PLANNING & ZONING AGENDA ITEM #6

SUBJECT: Approval of site plan for Gym Space LLC, 1110 SE Westbrooke Drive.

STAFF REPORT

Re: Gym Space, LLC Site Plan
Revisions from Comments Dated: 03-13-2013

Gym Space, LLC
TITLE SHEET/COVER SHEET
Associated Engineering Company of Iowa

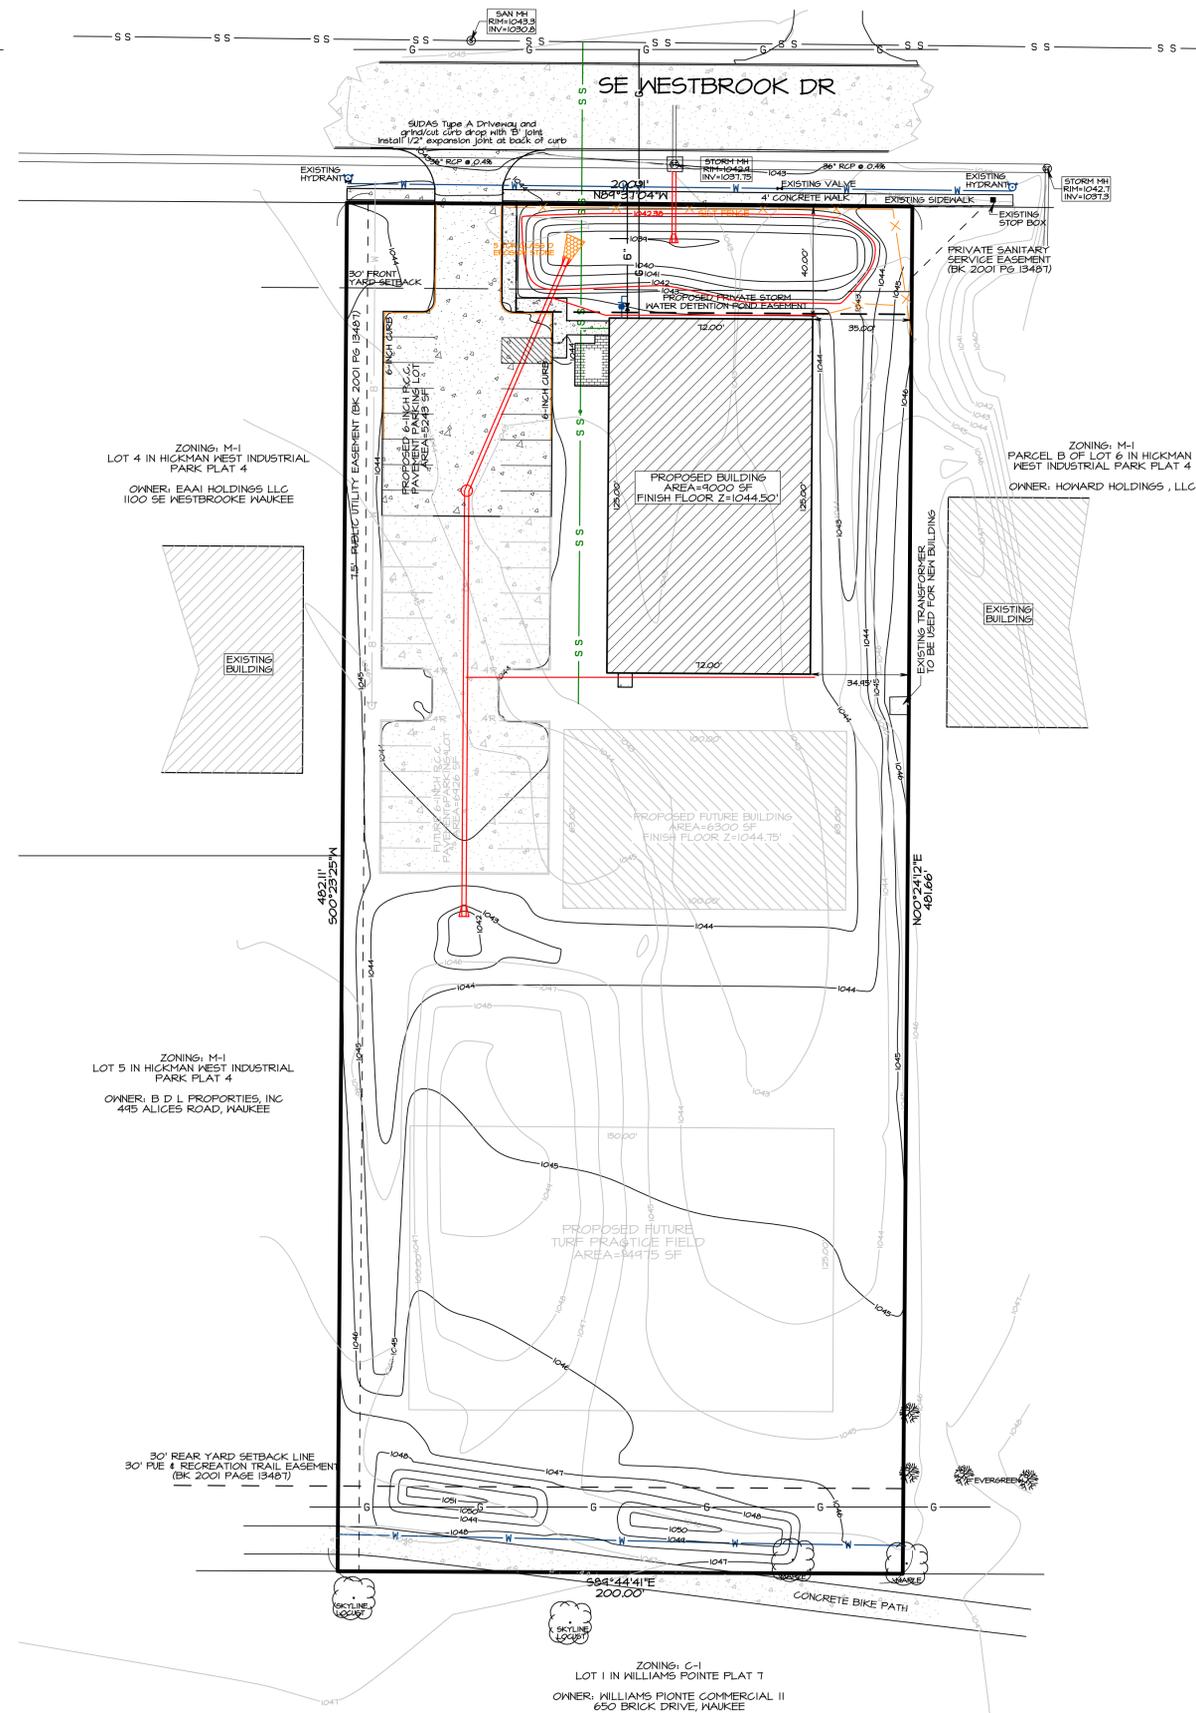
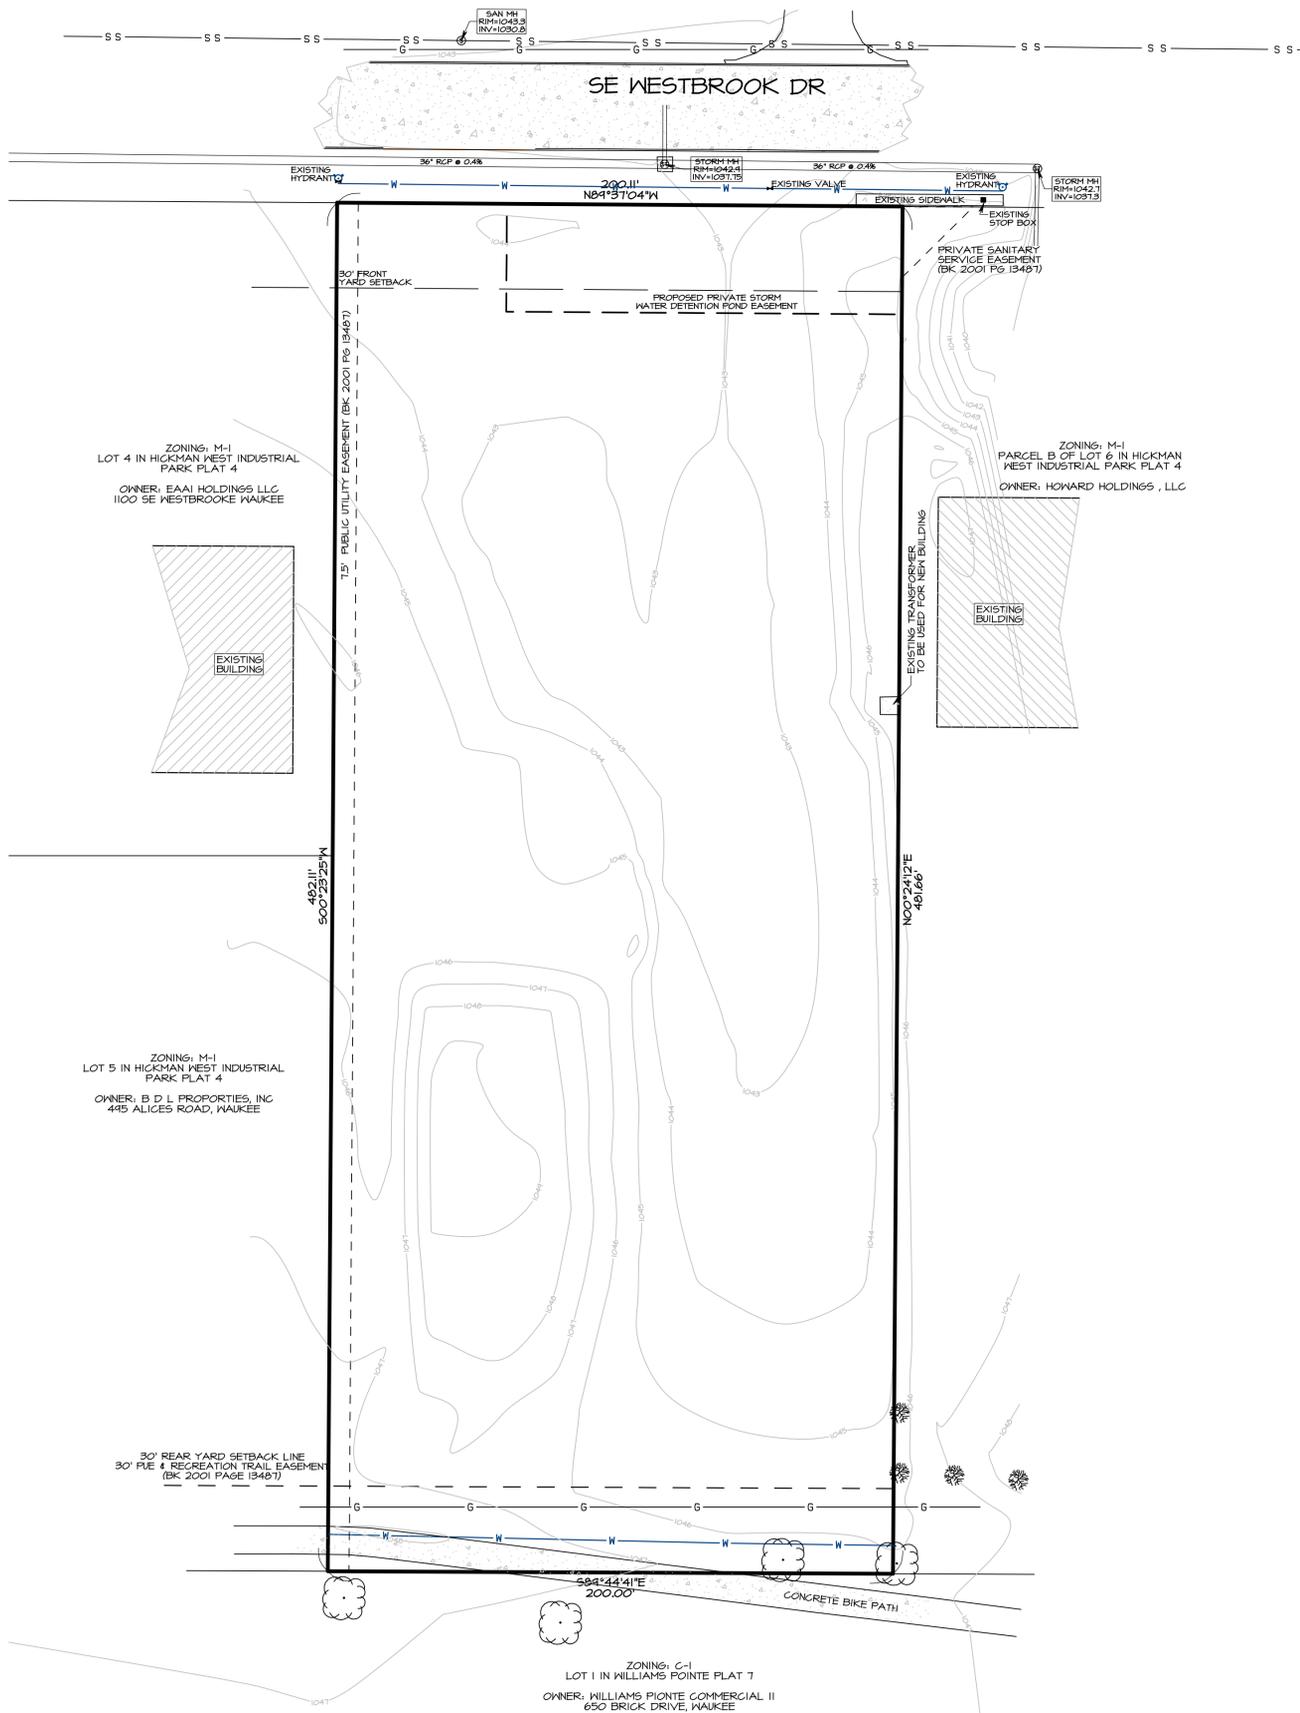
22. The total amount of area proposed to be disturbed as a part of Phase I should be indicated on the cover sheet for clarity in square feet.
23. **IDNR Sanitary and Water Permits should be provided for review and approval prior to any construction on the site.**

24. **A note should be added to the cover sheet indicating any proposed hydrants to include Storz connections (future hydrants).**

22. The total amount of area proposed to be disturbed as a part of Phase I should be indicated on the cover sheet for clarity in square feet.
23. **IDNR Sanitary and Water Permits should be provided for review and approval prior to any construction on the site.**

24. **A note should be added to the cover sheet indicating any proposed hydrants to INCLUDE STORZ CONNECTIONS (future hydrants). (See label on plan sheet at the proposed future hydrant location label)**

Gym Space, LLC
DEMOLITION PLAN & GRADING PLAN
Associated Engineering Company of Iowa

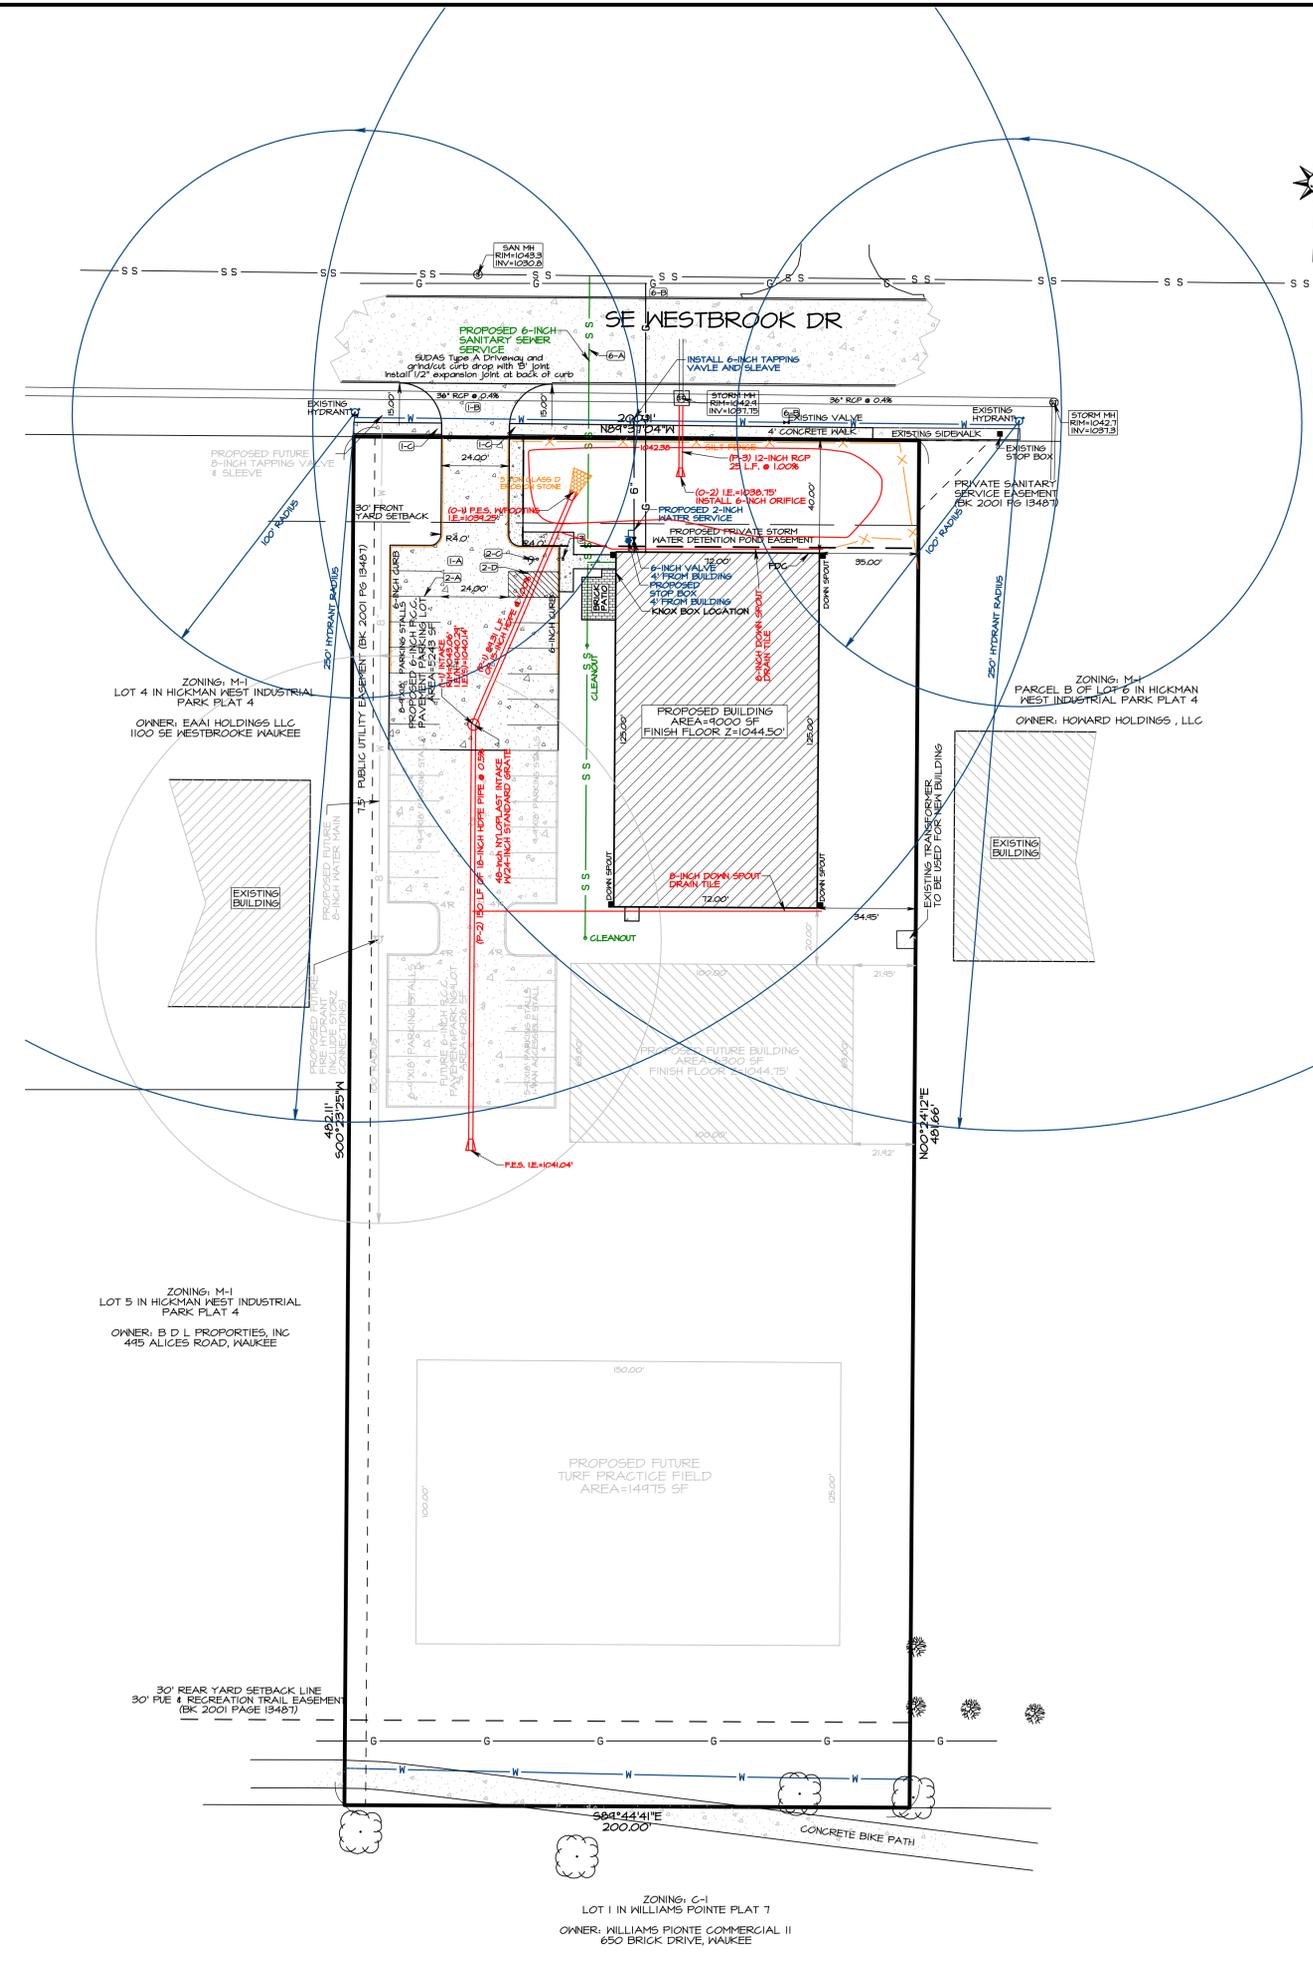
25. The date a site survey was completed for the property should be indicated on the demolition plan.
26. All existing easements should be indicated with recorded Book and Page on all sheets of the plan set.

27. All adjacent ownership and zoning information should be indicated on the site plan for clarity. Additionally, the lot, property owner information, and existing street conditions (north site access point) on the north side of SE Westbrooke Drive should be indicated on the plan set.

28. The existing 30-foot public utility and recreational trail easement running along the southern boundary of the lot should be indicated on the site plan.

29. Verify the location of any existing trees adjacent to the trail that were installed as a part of the recent trail construction this past year. The location and type(s) should be indicated on the plan set for clarity.

30. The proposed curb cut location on SE Westbrooke Drive should be revised to follow SUDAS Type A Driveway and grind/cut curb drop with 'B' joint. **The callout should also indicate installation of a 1/2" expansion at back of curb.**

37. ~~The 100 year flood limit of the detention pond should be indicated (labeled) and illustrated on the site plan for clarity.~~
38. **The location of any ground mounted mechanical units should be indicated on the site plan, which would include any A/C units.** Staff would request that the transformer be located a minimum of 2 feet away from the property line and dimensions provided for the proposed pad.

25. The date a site survey was completed for the property should be indicated on the demolition plan.
26. All existing easements should be indicated with recorded Book and Page on all sheets of the plan set.

27. All adjacent ownership and zoning information should be indicated on the site plan for clarity. Additionally, the lot, property owner information, and existing street conditions (north site access point) on the north side of SE Westbrooke Drive should be indicated on the plan set.

28. The existing 30-foot public utility and recreational trail easement running along the southern boundary of the lot should be indicated on the site plan.

29. Verify the location of any existing trees adjacent to the trail that were installed as a part of the recent trail construction this past year. The location and type(s) should be indicated on the plan set for clarity.

30. The proposed curb cut location on SE Westbrooke Drive should be revised to follow SUDAS Type A Driveway and grind/cut curb drop with 'B' joint. **The callout should also indicate installation of a 1/2" expansion at back of curb.**

37. The 100-year flood limit of the detention pond should be indicated (labeled) and illustrated on the site plan for clarity.
38. **The location of any ground mounted mechanical units should be indicated on the site plan, which would include any A/C units.** Staff would request that the transformer be located a minimum of 2 feet away from the property line and dimensions provided for the proposed pad. **(NO A/C TO BE INSTALLED)**

DETENTION OUTLET PIPE

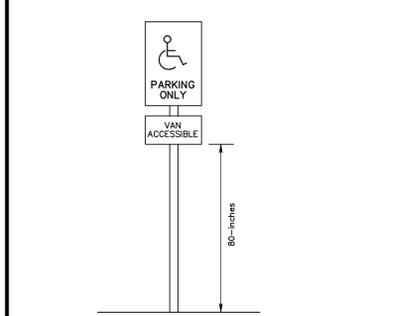
10. ~~A flared end section should be indicated on the plan set for the outlet of the detention pond.~~
Additionally, a detail should be provided identifying the placement of the orifice plate within the storm sewer on the plan set.

11. **A detail should be provided as a part of the plan set for the flared end sections indicating the use of a footing and apron guard.**
12. ~~The invert elevation of the detention pond outlet should be indicated on the site plan.~~

9. The storm sewer structure types should be indicated on the site plan for clarity.
10. A flared end section should be indicated on the plan set for the outlet of the detention pond. **Additionally, a detail should be provided identifying the placement of the oriface plate within the storm sewer on the plan set. (See detention pond outlet detail on sheet 3 of 4)**

11. **A detail should be provided as a part of the plan set** for the flared end sections indicating the use of a footing and apron guard. **(See detention pond outlet detail on sheet 3 of 4)**

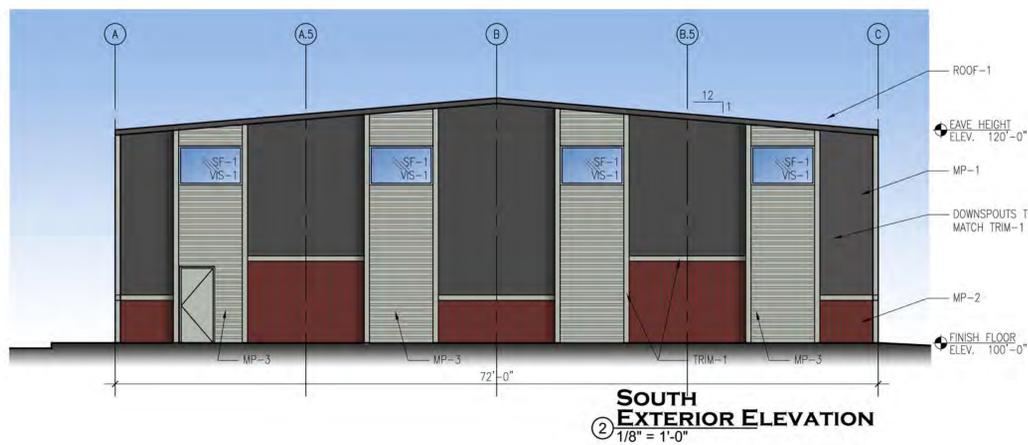
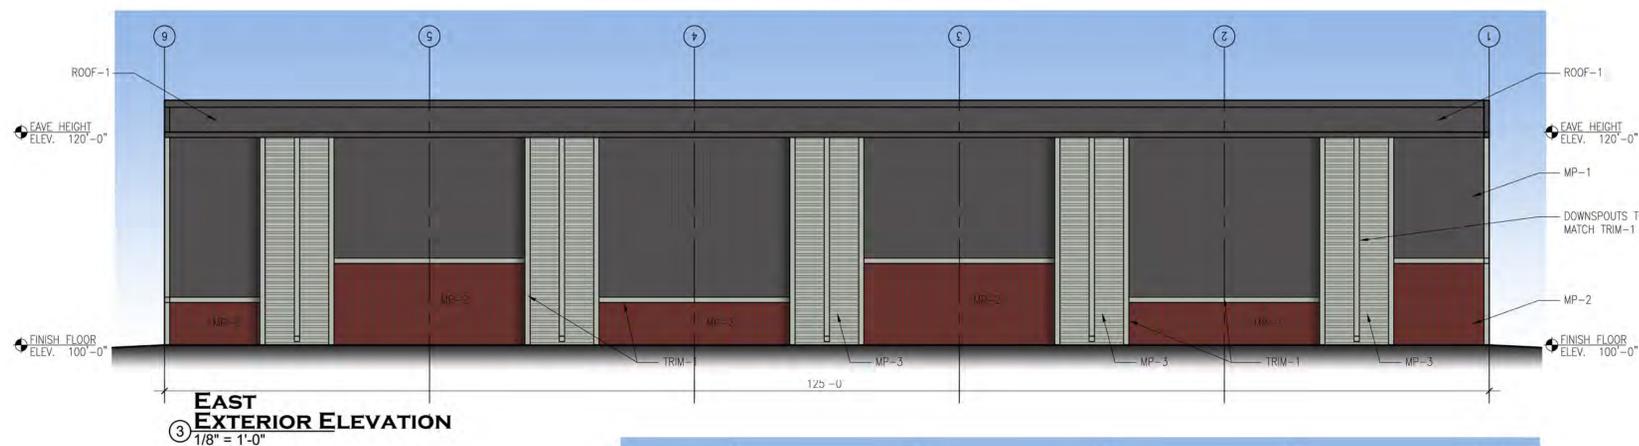
31. ~~The South Elevation should likely receive the same Parapet treatment as the North Elevation.~~
32. **The East Elevation should be updated to provide massing dimensions.**

33. **Verify as questioned previously that there are no other egress locations needing to be indicated on the elevations.**
34. ~~Verify that no rooftop mechanical units are being proposed as a part of this project. A note should be added to the elevation drawings indicating the mechanical screening to be provided as necessary to provide for adequate screening of the units.~~

35. **A note should be added to the elevation drawings indicating all hollow frame doors to be painted to match the adjacent wall color.**
36. ~~A note should be added indicating signage to be reviewed and approved by the Development Services Department under separate permit.~~

31. ~~The South Elevation should likely receive the same Parapet treatment as the North Elevation.~~
32. **The East Elevation should be updated to provide massing dimensions.**

33. **Verify as questioned previously that there are no other egress locations needing to be indicated on the elevations.**
34. ~~Verify that no rooftop mechanical units are being proposed as a part of this project. A note should be added to the elevation drawings indicating the mechanical screening to be provided as necessary to provide for adequate screening of the units.~~

35. **A note should be added to the elevation drawings indicating all hollow frame doors to be painted to match the adjacent wall color.**
36. ~~A note should be added indicating signage to be reviewed and approved by the Development Services Department under separate permit.~~
